TMI_908-GW(2)-01

Issue Identifier	Age IR	Age	Age Group / Order	Reference to Information Request	
TMI_908-GW(2)-01	GW(2)-01	1	CEA Agency	Reference to EIS Guidelines:	Part 2, Sections 9.1.1 and 9.1.2
				Reference to EIS / Appendix	n/a
				Cross-reference to Round 1 IRs	TMI_72-GW(1)-09, TMI_74-GW(1)-11, TMI_75-GW(1)-12, TMI_83-GW(1)-20, TMI_115-SW(1)-29
				<p>Identified Risks</p> <p>The groundwater model has a number of deficiencies, listed below, which raise uncertainties with the modelling exercise, the outputs of the model, and the effects assessments that incorporate those model outputs. These concerns are also tied with concerns raised in other IRs related to characterization of geochemistry on the site (see CEAA 31, 24 to 26 and 33), cover options for TSF and WRSAs (see CEAA 9 to 11 and 30), and TSF base and liner (see CEAA 14 and 29).</p> <ol style="list-style-type: none"> 1) Recharge rate uncertainty Recharge was based on very limited field observations which were conducted during unusually dry years (Appendix M of the revised EIS, Section 3.2 and Figure 9). Recharge rates have important implications for modelling the quantity of seepage. 2) Recharge rate uncertainty (WRA)

TMI_951-GW(2)-01B_Figure 3
Thickness of Sand and Gravel

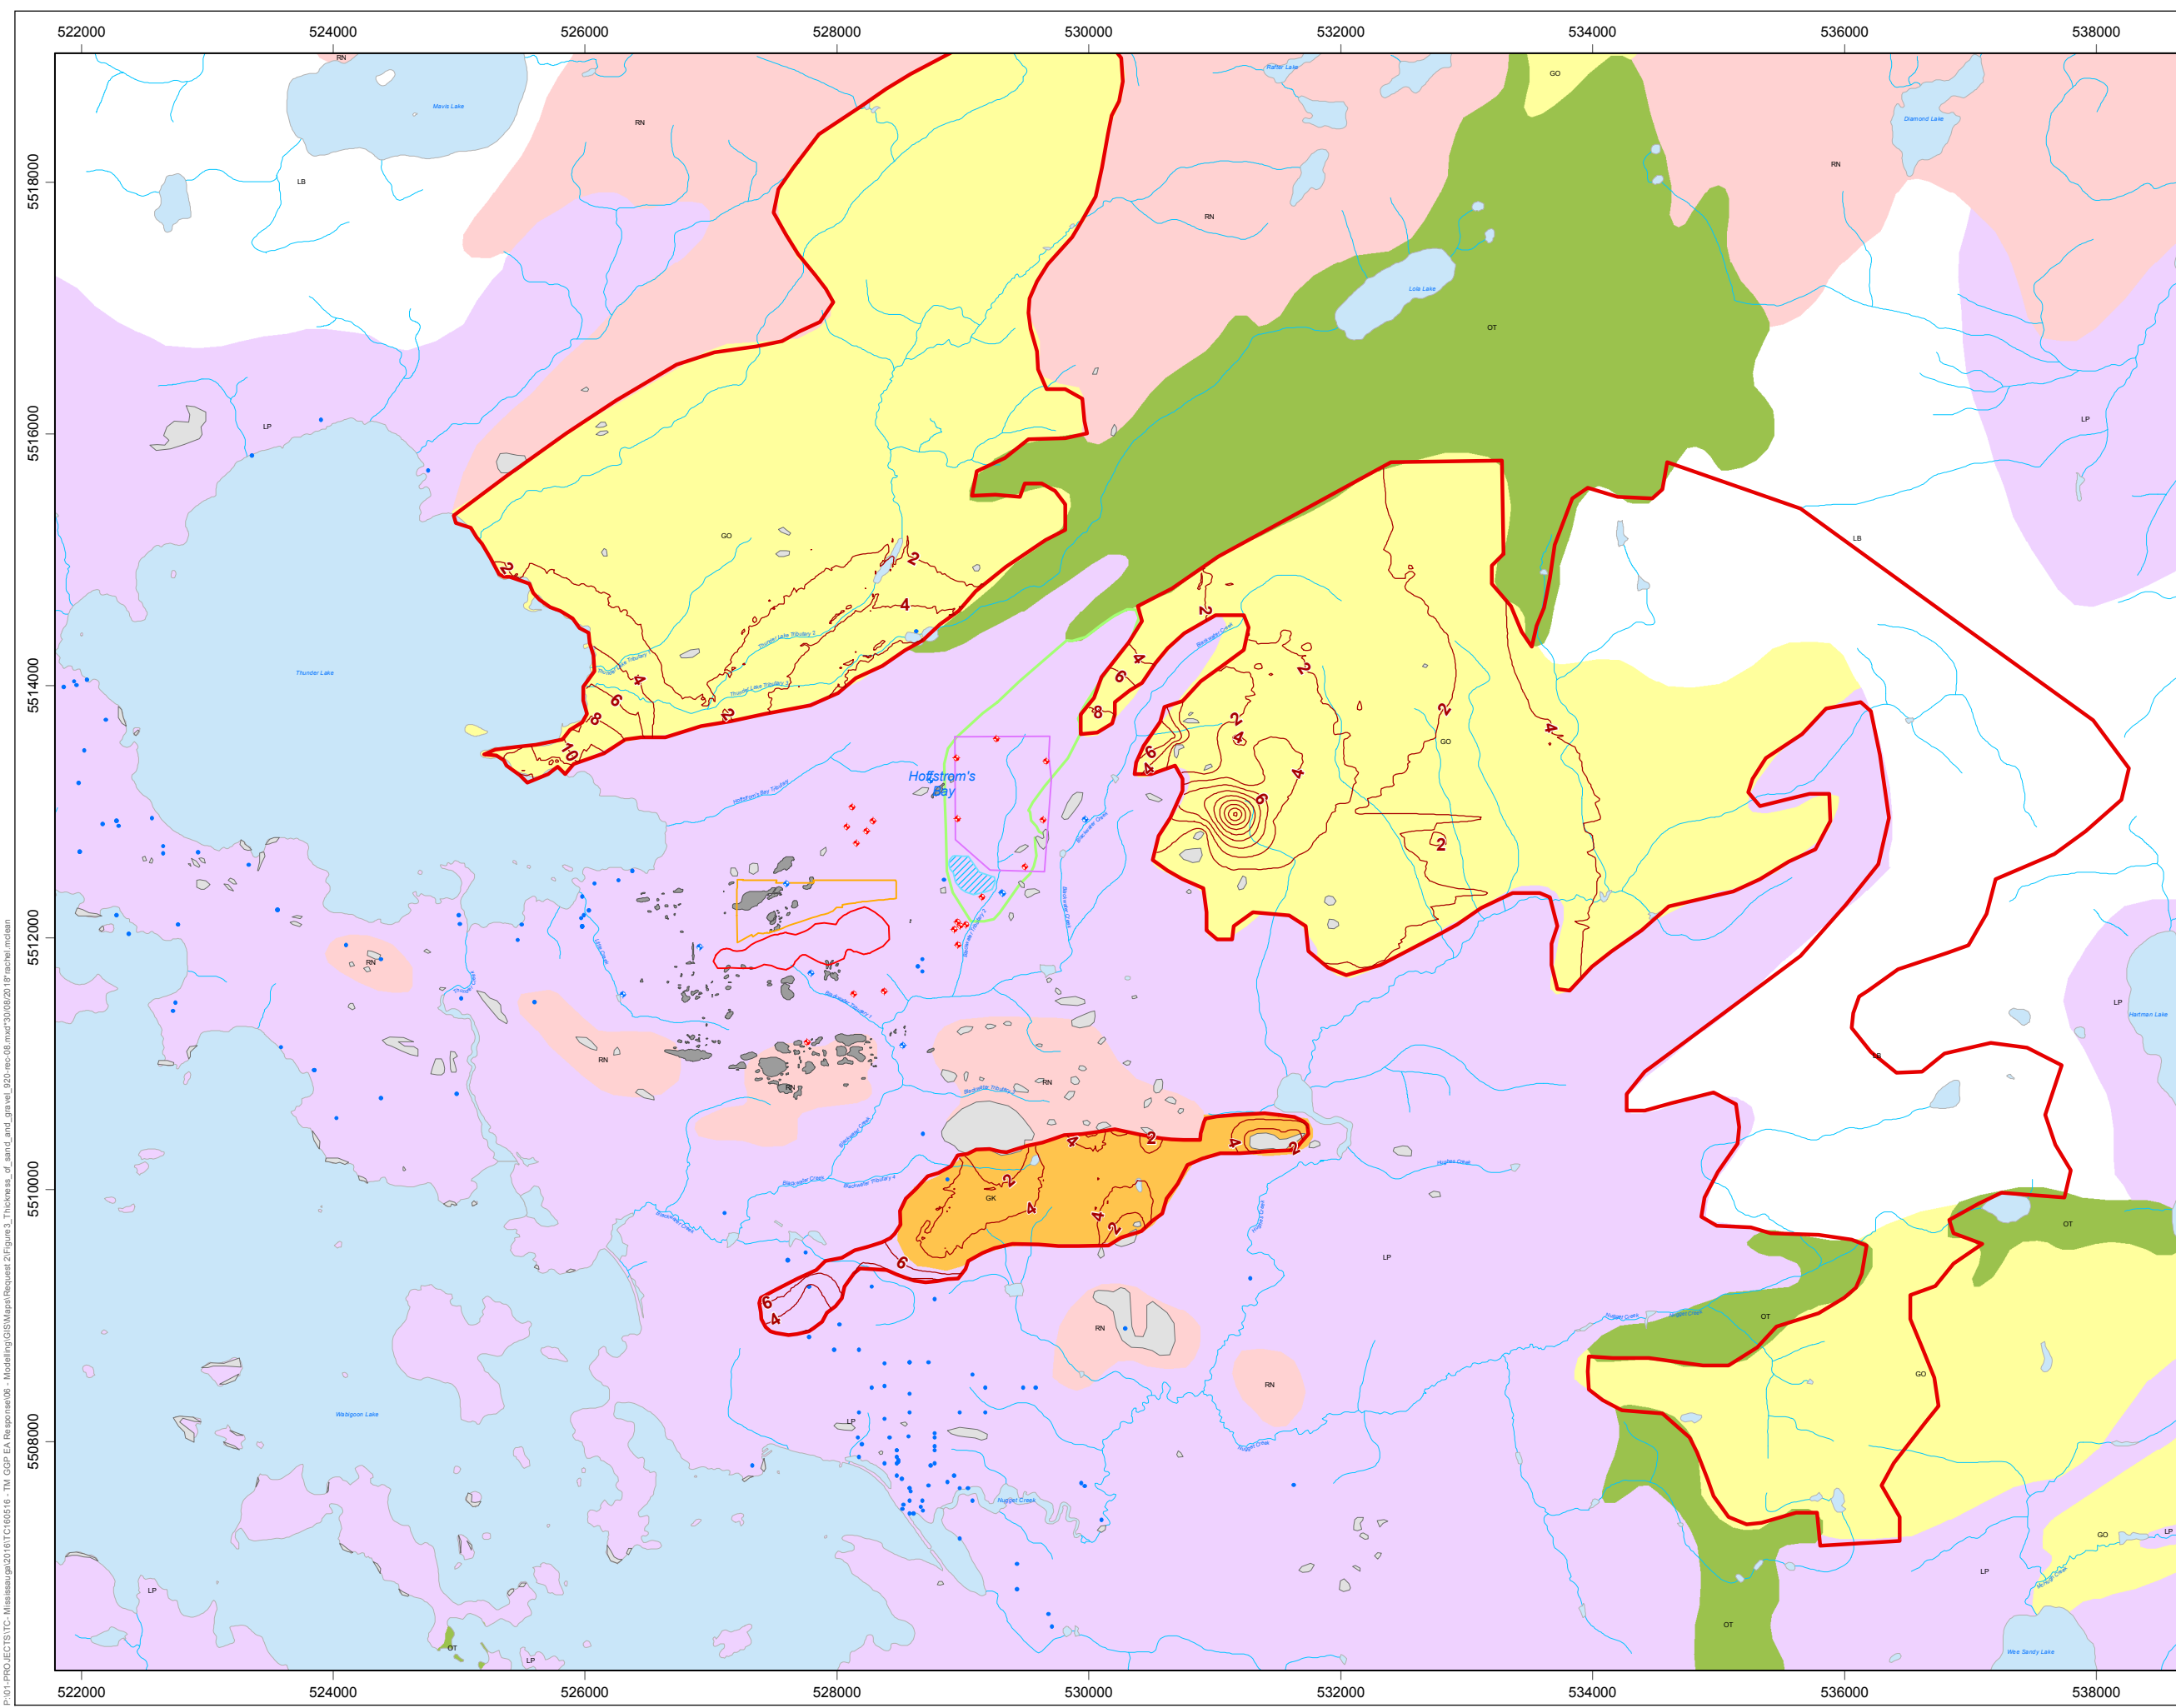
Issue Identifier	Age IR	Age	Age Groundwater Order	Requester's Information Request Response
				<p><u>Issue Identifier</u></p> <p>A. Provide an updated groundwater model that addresses all seven of the concerns raised in the “Context and Rationale” for this IR. Incorporate the findings from the IRs # MW(2)-08 and GW(2)-02 to GW(2)-04 in the revision of the model.</p> <p>B. Provide the potential range in seepage volumes (e.g. based on sensitivity analyses) from the TSF and WRSA. Also provide travel times for this seepage to various receptor locations. Include in this assessment, an explanation of how seepage volumes would be expected to flow through various geologic layers.</p> <p>C. Determine the capture efficiency of the seepage collection system, and assess the efficiency based on different ditch depths, and whether efficiency can be improved through the use of additional mitigation measures such as pump-back wells.</p> <p>D. Reassess the changes in water quality from seepage emanating from the TSF and WRSA and an updated groundwater model, taking the responses from Questions A to C into consideration.</p> <p>E. Revise the effects to fish and fish habitat and Indigenous health from impacted private groundwater wells taking the response from Question D into consideration.</p> <p>F. Describe additional mitigation measures to prevent adverse effects to fish and fish habitat and Indigenous health from impacted private groundwater wells, if necessary, taking into consideration the response to Question E.</p> <p>G. Characterize residual effects, if any, after the mitigation measures described in Question F have been implemented.</p> <p>H. Update the follow-up program for potential effects to fish and fish habitat and Indigenous health from impacted private groundwater wells, including objectives and any monitoring measures that will be implemented to verify the predictions of effects and evaluate the effectiveness of the proposed mitigation measures. If follow-up is not required, provide a rationale.</p> <p>I. Incorporate the findings from this IR into the revision of seepage water quality assessment requested in IR# MW(2)-06.</p> <p>THIS IR SUPERSEDES IR# GW(2)-01.</p> <p><u>Response</u></p> <p><u>Part A:</u></p> <p>Treasury Metals had undertaken a review of the inputs, assumptions and outputs of the groundwater model in response to the seven concerns raised in the “Context and Rationale”. As detailed below, the review did not identify deficiencies in the assumptions and inputs that would warrant updating the groundwater model. The groundwater model used for the Goliath Gold Project was used to characterize the transport of seepage from the WRSA and TSF, as well as the rate of inflow into the open pit and underground mine workings. Detailed justification for retaining the</p>

Issue Identifier	Age IR	Age	Age Groundwater Order	Request Reference Information Request Response
				<p>Goliath Gold open pit, and the Victor kimberlite deposit is situated in several karstic dolostone formations. The groundwater pumping rates for the Victor Diamond open pit are two order of magnitudes greater than predicted for the Goliath Gold open pit.</p> <p>Therefore, it would not be reasonable to expect the Goliath Gold Project to collect as many of hydrogeological/geotechnical measurements as were collected for the Detour Gold, Rainy River Gold or Victor Diamond mining projects.</p> <p>Regarding the information in Table 5.6.2.2-1 of the revised EIS (April 2018), these data are almost all correct and are the same as given in the AQTESOLVE analysis sheets provided in Appendix C of Appendix M of the revised EIS (April 2018) with the geological data corresponding to the borehole logs of Appendix C of Appendix M of the revised EIS (April 2018).</p> <p>The exception is for Well 5A where the hydraulic conductivity should have been rounded to 1.1×10^{-6} m/s rather than 1.0×10^{-6} m/s. The geometric mean and arithmetic mean should be 9.1×10^{-7} m/s and 9.6×10^{-7} m/s rather than 9.2×10^{-7} m/s and 9.8×10^{-7} m/s, respectively. These typos concerning the means also occur in Section 4.1 of Appendix M of the revised EIS (April 2018). The hydraulic conductivity values are largely representative of silty sands that occur at the base of the overburden and are consistent with published literature (e.g., Freeze and Cherry, 1979). There is one anomalous value (Well 5A), which gave a value of 1.1×10^{-6} m/s, untypical for the screened unit of clay, as noted in Section 4.1 of Appendix M of the revised EIS (April 2018). The log for Well 5A (Appendix A of Appendix M of the revised EIS [April 2018]) shows three split spoons across the screened interval, which all indicate clay. It is possible that the higher than normal hydraulic conductivity may be due to a thin sand or gravel seam occurring between the split spoon samples not being recognized during drilling of the borehole.</p> <p>4. Thickness of the Overburden</p> <p>The upper three (3) layers of the groundwater model correspond to:</p> <ul style="list-style-type: none"> Model Layer 1 is the surface layer and corresponds to the Clay, Sand and Gravel, the upper layer of the Sand-Clay/Silt Sand unit or bedrock knoll, depending on the surficial geology. Model layer 2 corresponds to the Basal Sand unit in the areas where it is expected to be thicker than 0.3 m. The basal band layer is discontinuous layer at the base of the clay, that is, on average, 3 to 4 m thick, when present. Model layer 3 corresponds to the weathered Shallow Bedrock unit, which was assumed to have a uniform thickness of 7 m. It is widely recognized that the shallow weathered and fractured bedrock tends to be the more permeable than the deeper bedrock in a shield crystalline bedrock setting, such as occurs at the Goliath Gold Project. <p>The thickness of the overburden, basal sands vary over the modelling domain based on the available data. TMI_951-GW(2)-01B_Figure_1, TMI_951-GW(2)-01B_Figure_2, and TMI_951-GW(2)-01B_Figure_1 show the thickness maps for the Basal Sands (Model Layer 2), Clay (Model Layer 1) and Sand and Gravel (Model Layer 1 and</p>

Issue Identifier	Age IR	Area	Age Groundwater	Request Reference
				<p>2) respectively. For each of the maps, surface water bodies, private wells and monitoring wells, as well as the mining facilities are shown. Bedrock sits beneath the Basal Sand, Clay, and Sand and Gravel layers, with the upper 7 m identified as weathered and fractured shallow bedrock.</p> <p><u>5. Porosity estimates</u></p> <p>To clarify, 0.01 (or 1%) was used as the kinematic porosity for the shallow bedrock, not the total porosity. When trying to understand the travel times for seepage in bedrock, the parameter of greatest importance is the kinematic porosity (or effective porosity). The kinematic porosity, which describes the ability of a fluid to travel through a media, is always lower than the porosity. Kinematic porosities for weathered bedrock provided in literature (Worthington, Smart and Ruland, 2012), suggests that values in the range of 0.01%–0.1% are possible carbonate aquifers, but posits a value of 1% is possible. The kinematic porosity of 0.01 used for the groundwater velocity calculation (memo to Mark Wheeler, Treasury Metals; “Additional Hydrogeological Information”, dated March 29, 2018, as appended to Appendix M) represents the porosity of open, weathered fractures at the bedrock surface. The Basal Sand at the base of the overburden is discontinuous as noted in the memo referred to above. Nevertheless, as fractures in the shallow bedrock will also be discontinuous, it is correct that flowpaths</p> <p><u>6. Particle Tracking</u></p> <p>Particle tracking has been undertaken with the groundwater model representing the ultimate dewatered mine condition with particles released from the TSF. As described in the response to TMI_911-GW(2)-04, the particle tracking plots for TSF during operations (TMI_911-GW(2)-04_Figure_1) show that, of the seepage leaving the TSF, 46% is captured by the open pit; 34% is captured by the TSF perimeter drains; 14% is captured by the minewater pond, and 6% escapes the operations area and reports to Blackwater Creek. The proportion that escapes the operations area to report to Blackwater Creek occurs along the eastern perimeter of the TSF. The particle tracking for the WRSA during operations (see TMI_911-GW(2)-04_Figure_2) indicates that all water seeping from the base of the uncapped WRSA during operations is captured by the open pit.</p> <p><u>7. Sensitivity Analyses</u></p> <p>Sensitivity analyses have already been undertaken with the groundwater model for the shallow bedrock and basal sand as shown in Table 9 of Appendix M to the revised EIS (April 2018). The focus of this sensitivity analysis was on the identification of seepage volumes into the open pit and underground mine workings, instead of the effects on the rates of seepage from the WRSA. As detailed in the responses to TMI_909-GW(2)-02 and TMI_911-GW(2)-04, all of seepage from the uncapped WRSA during operations and closure will be captured by the open pit, and will not reach the receiving environment. The uncapped WRSA scenario will only exist during operations and for a short period of time during closure when a low-permeability dry cover will be constructed over the WRSRA as described in Section 3.16.8. The multi-layer, low permeability dry cover over the WRSRA is intended to reduce the rate of infiltration into the</p>
